**67 ST HILDAS WAY, GRAVESEND
PLANNING STATEMENT**

Eagle Concepts Ltd (ECL) on behalf of Miss F Bollen

October 2024

Figure 4: Proposed layout in current application

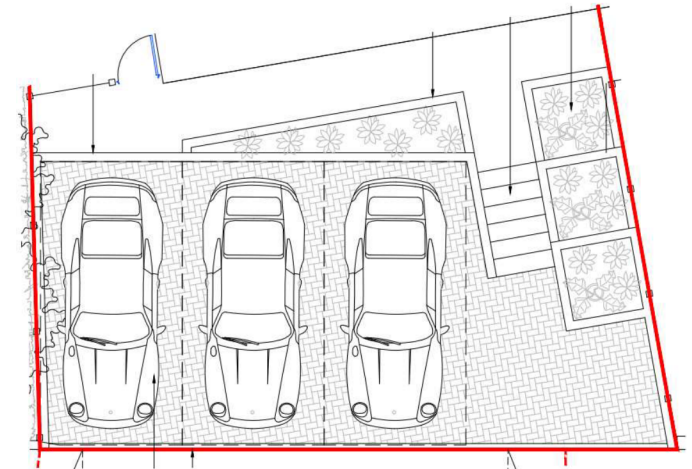
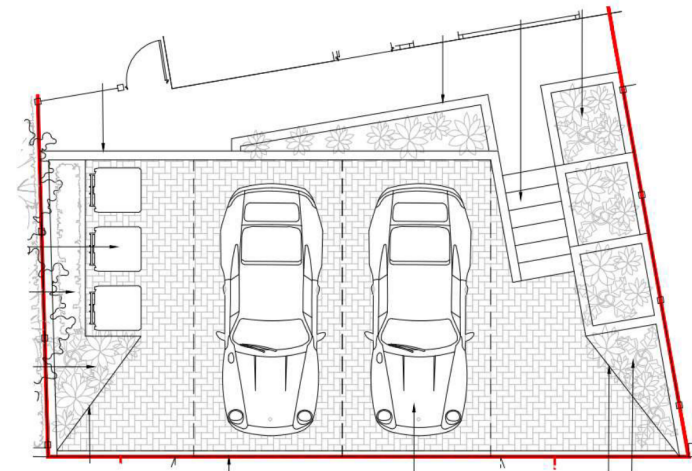
- 3.3 We understand the term 'of poor design' to refer to the replacement of the grass lawn, hedge and dwarf wall with a large expanse of hard landscaping, which the council feels is excessive. The design has evolved to reduce the number of bays by one, to a total of two spaces, both 2.5m x 5.0m in size.

- 3.4 Removing the parking space on the left-hand side opened up the opportunity to use the rear of that space to store the bins, with the front and side of the space given to soft landscaping. A symmetrical planter has been added to the right-hand side, which adds balance to the elevation and has a positive impact upon the street scene.

- 3.5 The net effect of removing one space has a positive impact on the soft to hard landscape ratio. Within the original design the ratio of hard to soft landscape was 87% hard and 13% soft. The four raised planters in the original design have been retained, and in addition two symmetrical flower beds are proposed at the front of the driveway, adjacent to the back of footpath, with a further hedgerow proposed along the left-hand side of the driveway. This design improves the ratio of soft to hard landscaping such that 22% is soft landscaping and 78% is hard.

- 3.8 The original proposal was for three parking spaces, each measuring 2.4m x 4.8 which equated to 34.6m² of parking space. The current proposal has reduced the number of spaces by one, to two spaces, and increased the size of both to 2.5m x 5.0m which equates to 25m², a reduction of nearly 10m². This is in line with SPG 4 - KCC Parking Standards (2006) and Gravesham's Householder Extensions/Alterations Design Guide (2021).
- 3.9 Pedestrian visibility splays have been provided on drawing 0190-EAG-00-00-DR-V-104, measuring 2.0m x 2.0m in accordance with Gravesham's Householder Extensions/Alterations Design Guide (2021).
- 3.10 Vehicular visibility splays have been provided on drawing 0190-EAG-00-00-DR-V-104, measuring 2.4m x 43m in accordance with Manual for Streets.

Figure 6: Proposed layout in current application showing additional planting to reduce the large expanse of block paving and soften the design with strategic planting.

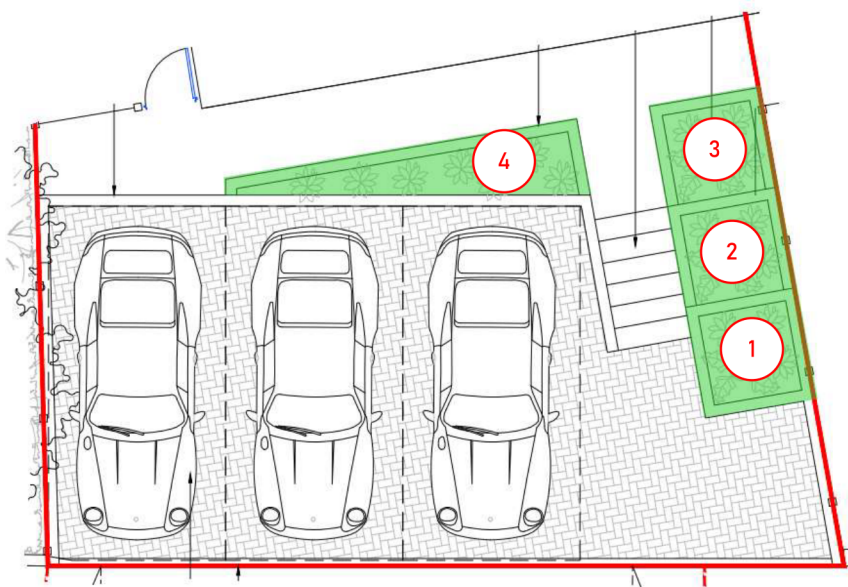
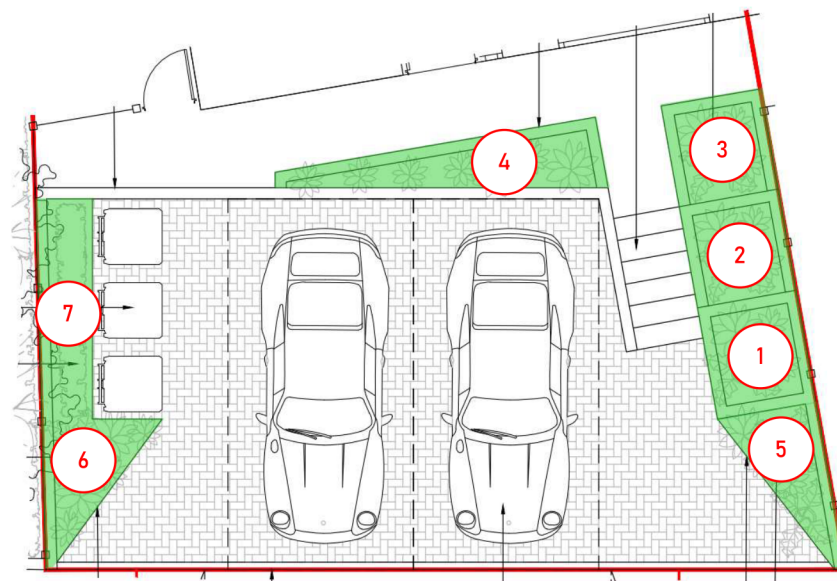
Figure 5: Proposed layout in Refused application showing four raised planters, deemed by Gravesham to be too few in proportion to the hard landscaping

- 1 Raised planter, 1.0m x 1.2m x 0.3m high min, 0.48m max.
- 2 Raised planter, 1.0m x 1.2m x 0.3m high min, 0.48m max
- 3 Raised planter, 1.0m x 1.2m x 0.3m high min, 0.75m max
- 4 Raised planter, 0.2m wide min, 1.0m max, x 4.5m x 0.75m high
- 5 Flower bed at ground level, 1.2m x 2.2m
- 6 Flower bed at ground level, 1.5m x 2.0m
- 7 Proposed hedge to match existing, 3.0m long, 1.0m wide, 1.5m high

Figure 8: Proposed layout in current application. The bins would be screened behind the planting. This arrangement allowed sufficient space to pull the wheelie bins out to the street past the parked cars.

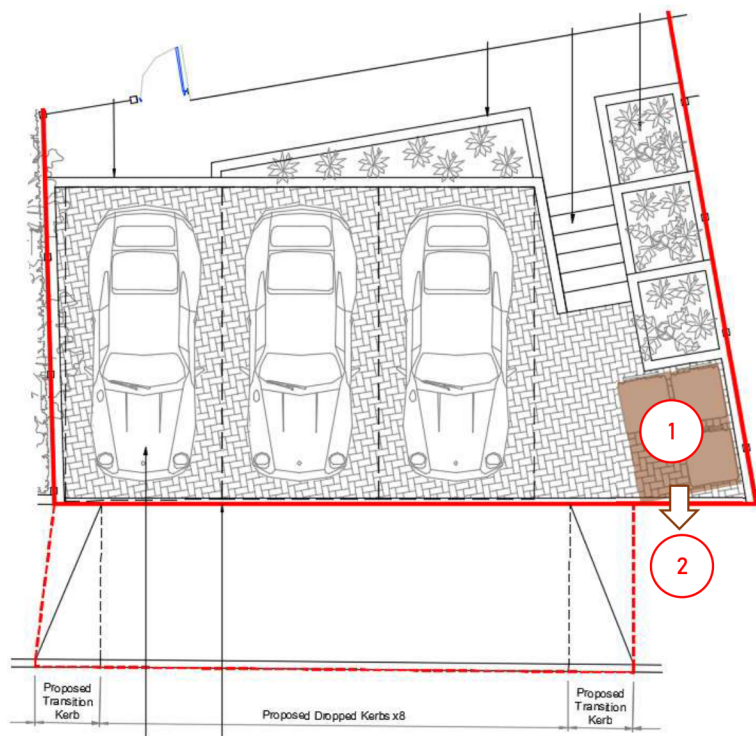
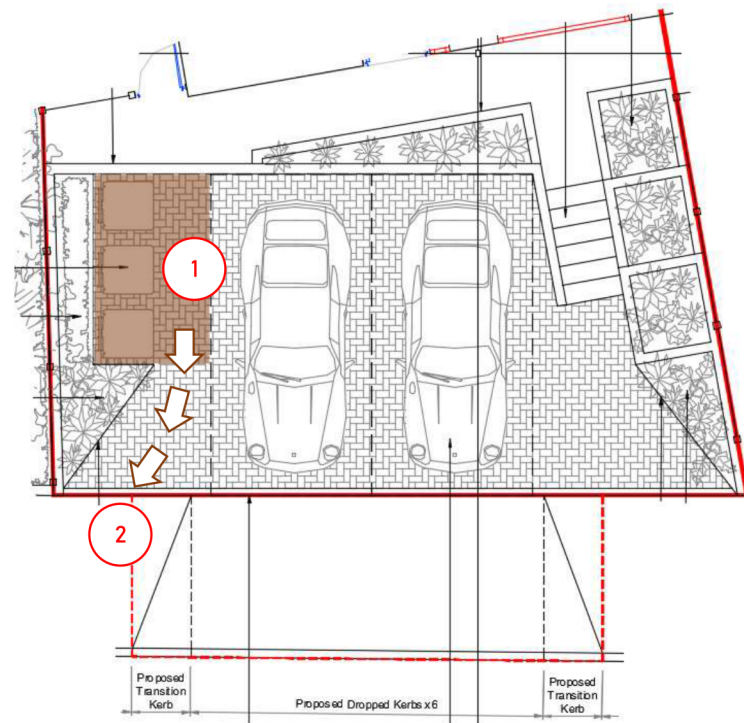
Figure 7: Proposed layout in Refused application. The bin location was not identified in the previous application; however, the intention was always to store the bins in the location as shown above.

- 1 Allocated refuse storage area on the property for three wheelie bins (general waste, recycling and green waste)
- 2 The bins would be pulled onto the back of footpath on collection days.

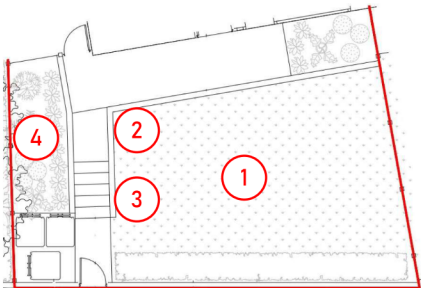
- 7.2 The existing lawn is in a very poor condition as can be seen in picture 1. There are weeds and rubble interspersed into the grass and the steepness of the gradient makes it an unusable space.

- 7.3 The existing retaining wall around the grass has collapsed at the bottom corner of the lawn over approximately 2m, as well as approximately 1m adjacent on the return to the bottom step, as can be seen in pictures 1 & 2. Not only are loose bricks a hazard, in wet conditions mud spills down across the steps and footway making it treacherous to walk through.

- 7.4 The brick wall supporting the planting border on the left-hand side of the path has also collapsed as can be seen in picture 4. This too leads to hazardous mud spillages in wet conditions.

- 7.5 The existing site plan implies that the lawn is immaculate and the border in picture 4 is full of healthy plants when in fact the soil is in such poor condition that nothing grows there, at the detriment of the local amenity.
